CITY PLAN COMMISSION STAFF REPORT

CD-CPC-2025-00081, -00080, -00082

Bungalows at Maple Woods

Corrections Report

OVERALL SITE PLAN

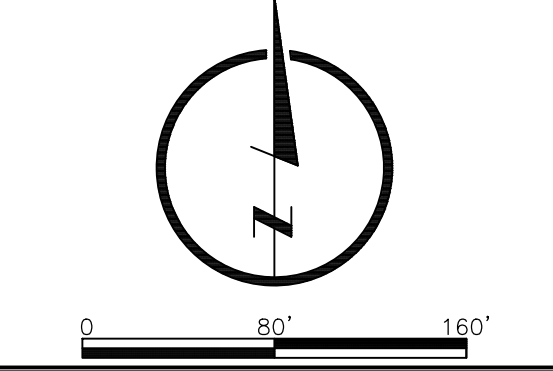
2. Add a sidewalk connection from ROW to the development along the southern driveway/access road. Connect the paths between units to the sidewalk along N Prospect Ave. (8/04/2025)
